February 19, 2019

SUBJECT: Incomplete Letter – Application No. SUB-18-04 application for 12-lot Subdivision at 22870 Weatherhill Road

Engineering:

FILE: P:\463-003 Weatherhill Road Phase 1\dwg\plan\463-003-6.plat, Layout: 6 PRELIMINARY PLAT, Plot Date: 2/15/2019 9:39 AM, by: Jacob Snyder

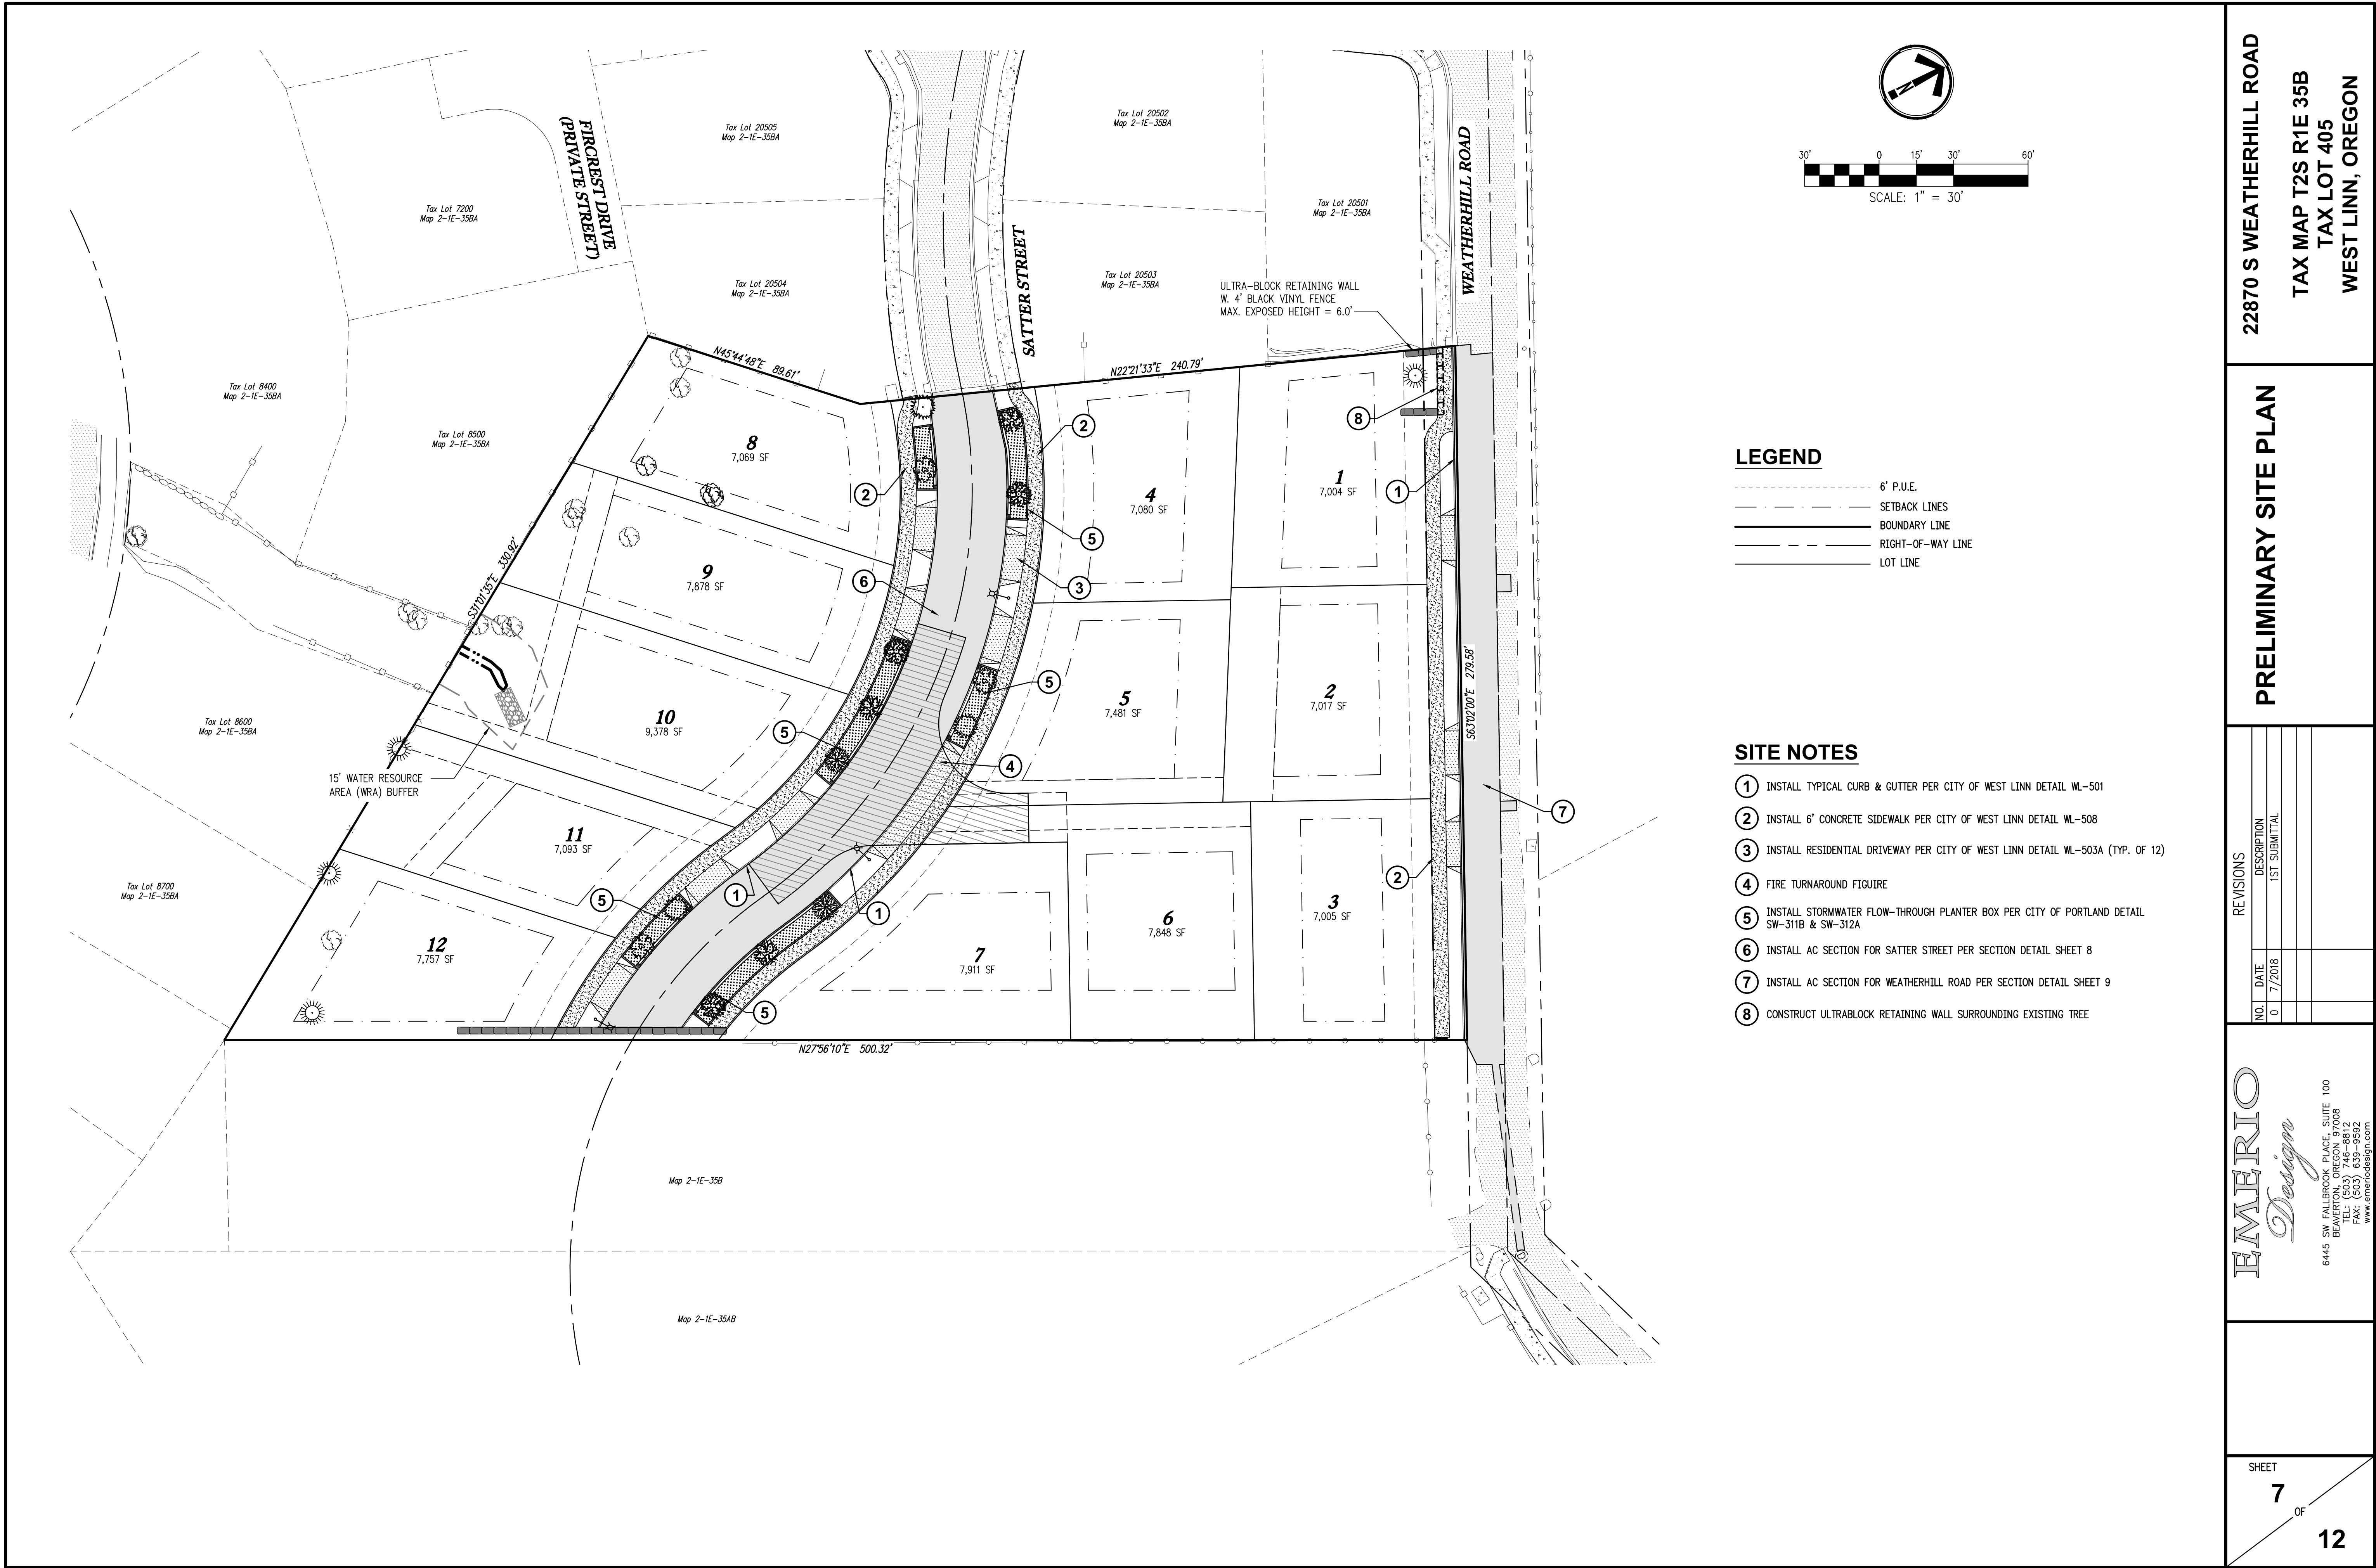
2. Need to add a turnaround approved by TVF&R at the east end near lot 7 and 12 in case the 22864 Weatherhill Subdivision does not go through.

RESPONSE: The applicant has added a turnaround at the east end near lot 7. The applicant is proposing to use the flag pole for lot 6 as the fire turnaround until Satter St. is extended with the development of the adjacent property to the east (i.e. 22864 Weatherhill Rd.). See sheet 6 of the revised plan set for more detail.

FILE-P:\463-003_Weatherhill_Road_Phase_1\dwg\plan\463-003_8street_Layout_8_SATTER STREET PLAN PROFILE AND STORM LINE_Plot Date: 2/15/2019 10:19 AM, by: Jacob Snyder

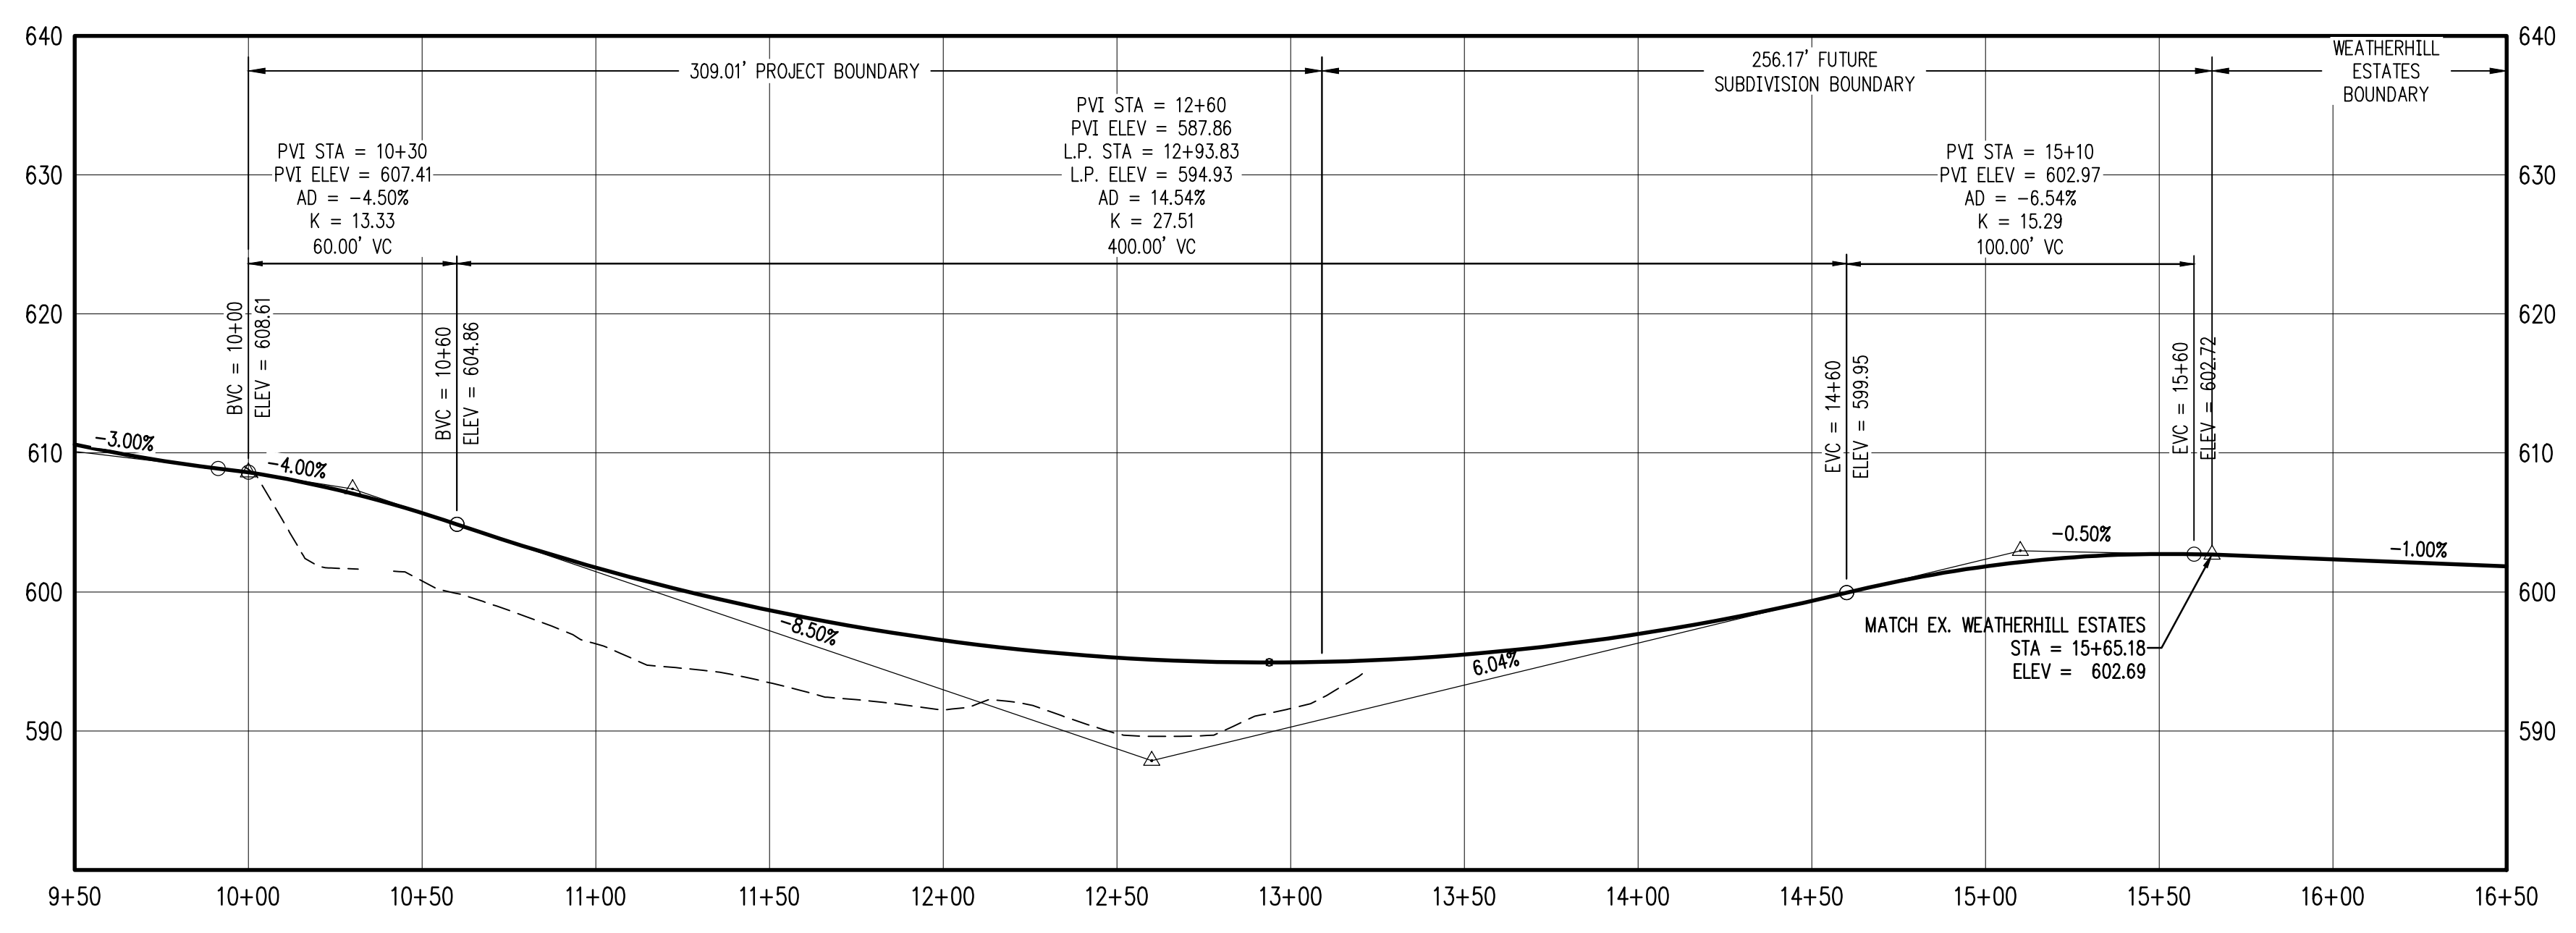
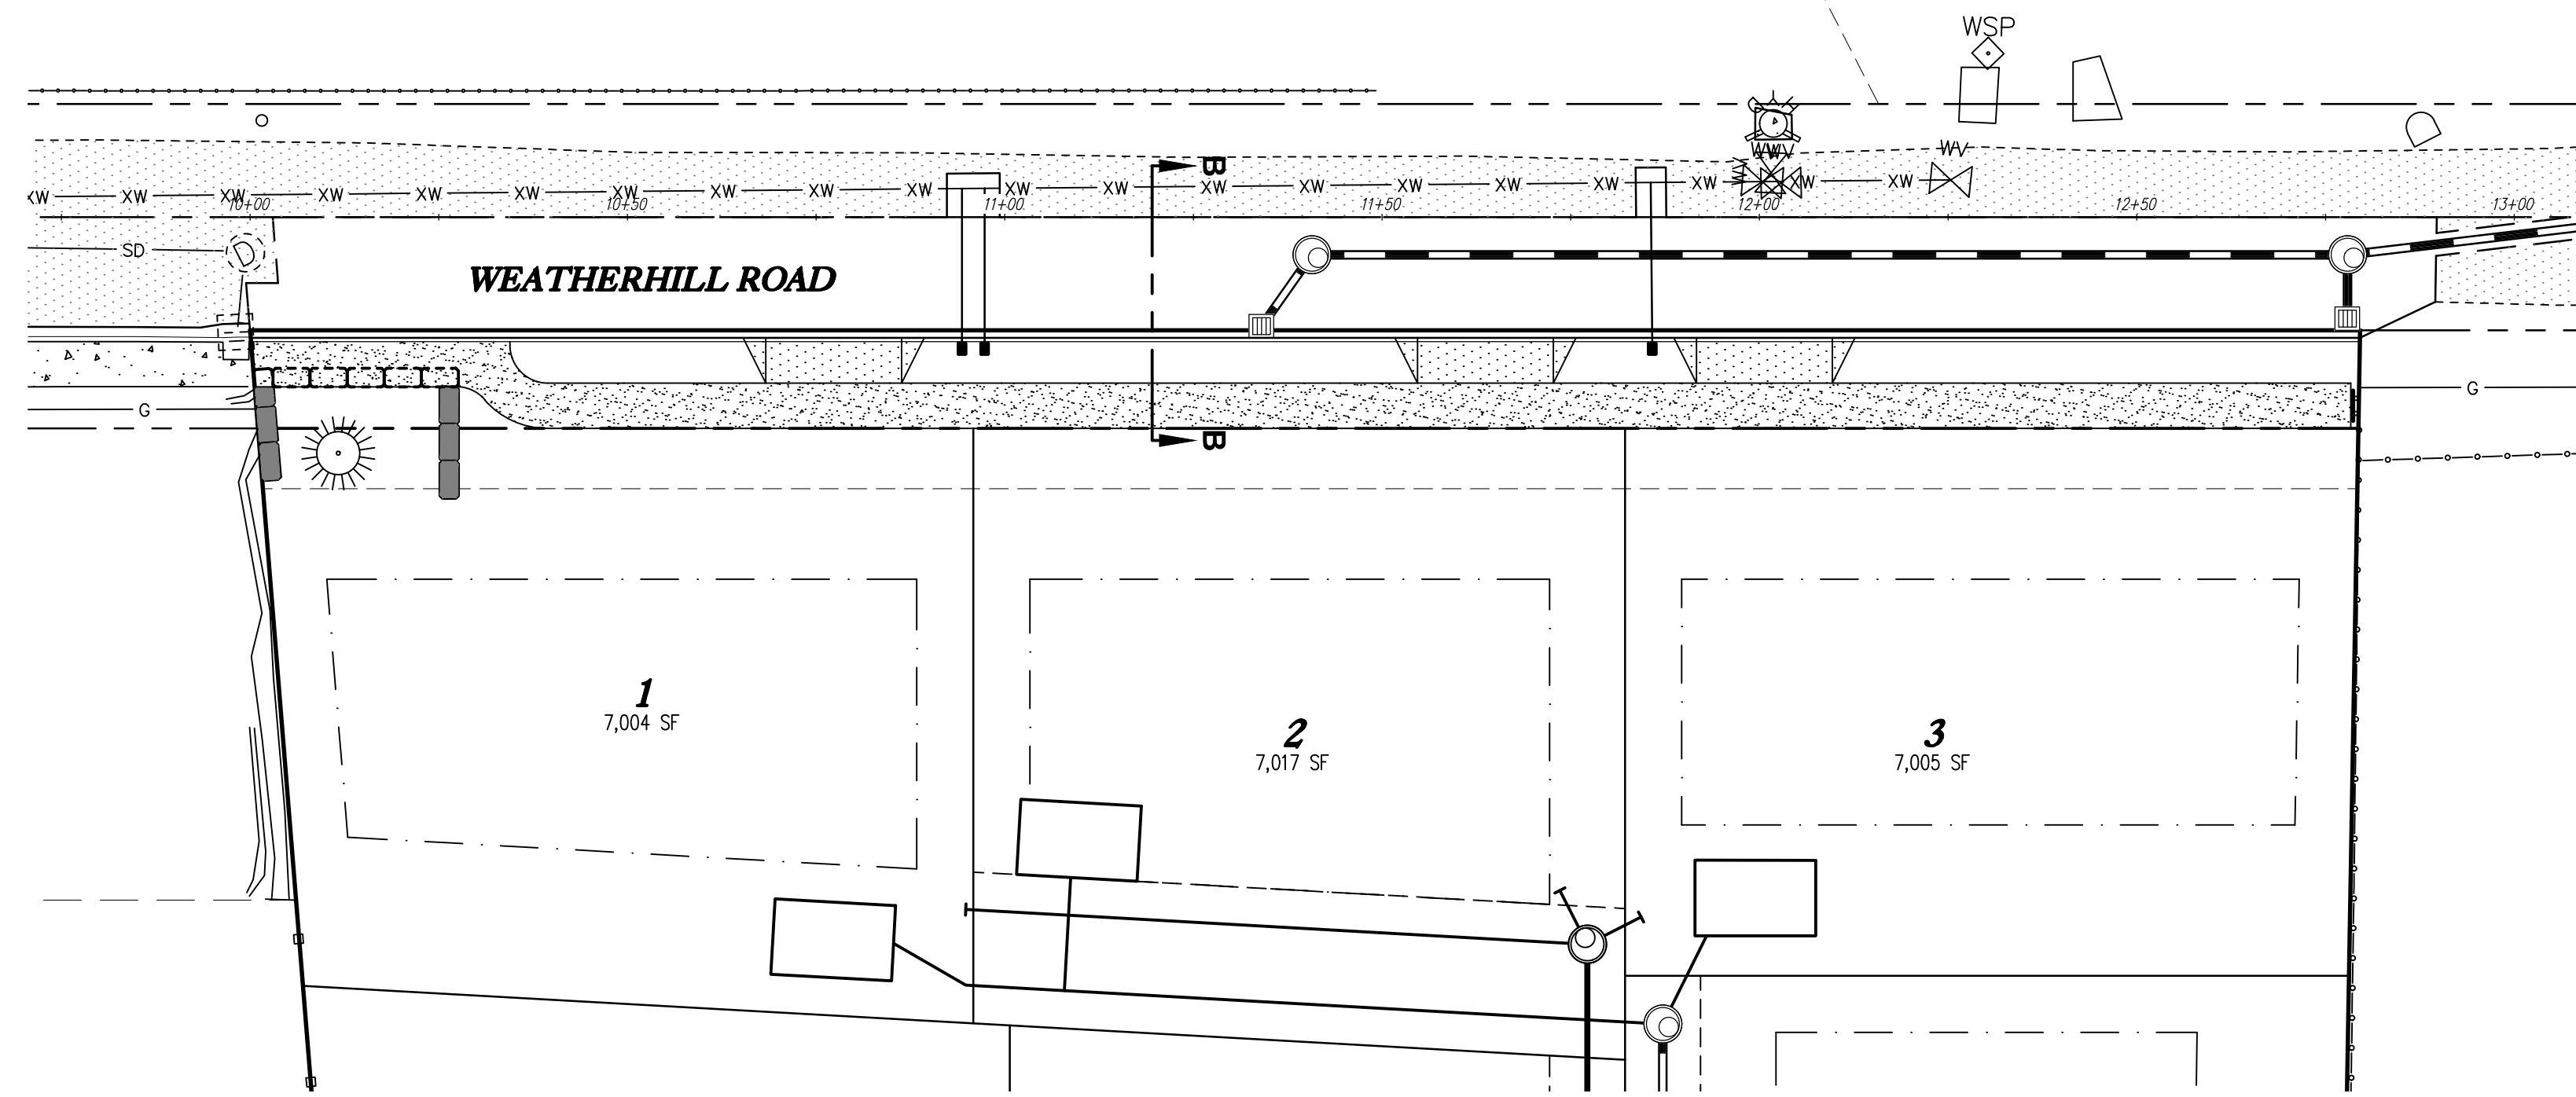
1. The centerline of the road needs to be the true centerline of the road as parking is not prohibited on one side or another.

RESPONSE: The applicant has revised the centerline for Satter St. so that it is a "true" centerline. See submitted revised plan set for more detail.
